Site Map
Upper Shaker Lake Dam
File Number: 1314-002

Dam Safety Inspection Checklist

Name of Dam: Upper Shaker Lake Dam
 Date of Inspection: 9-30-2014
 File Number: 1314-002
 Class: I
 Haz.: I, Height: III, Volume: III

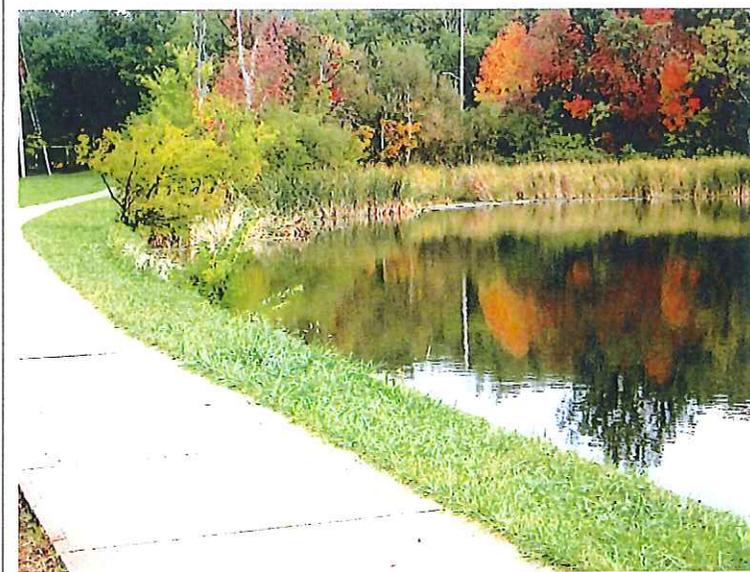
Stone wall along the upstream slope on the right side of the dam. Note the trees and vegetation growing through the wall.

Stone wall and crest looking towards the left end of the dam. Note the new (lighter color) riprap on the downstream slope. The new riprap replaced riprap that had been displaced during an overtopping flood earlier in the year.

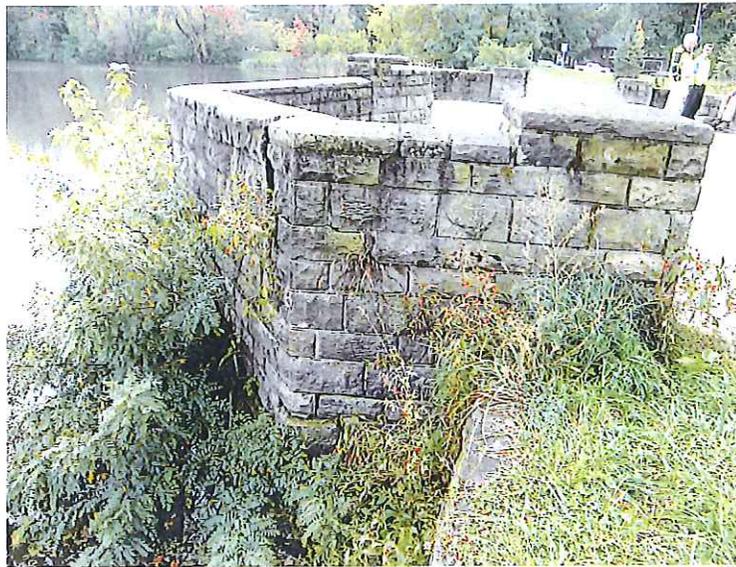
Principal spillway inlet. Note the flat trashrack and small openings.

Note the cracks in the masonry wall above the principal spillway inlet.

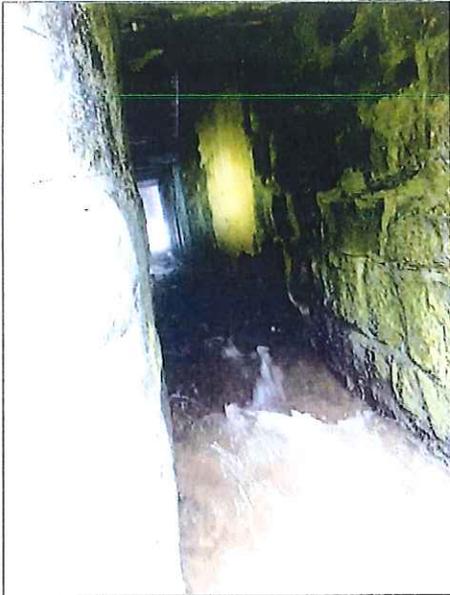
Interior of the principal spillway conduit. Note that portions of the conduit have been braced with steel I-beams due to concerns of roof stability.

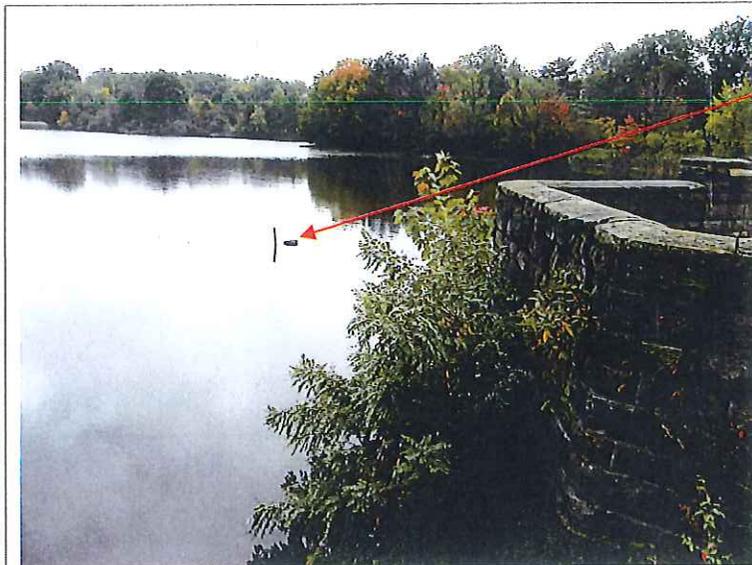
The 4-inch drain pipe was located just downstream of the principal spillway conduit outlet.
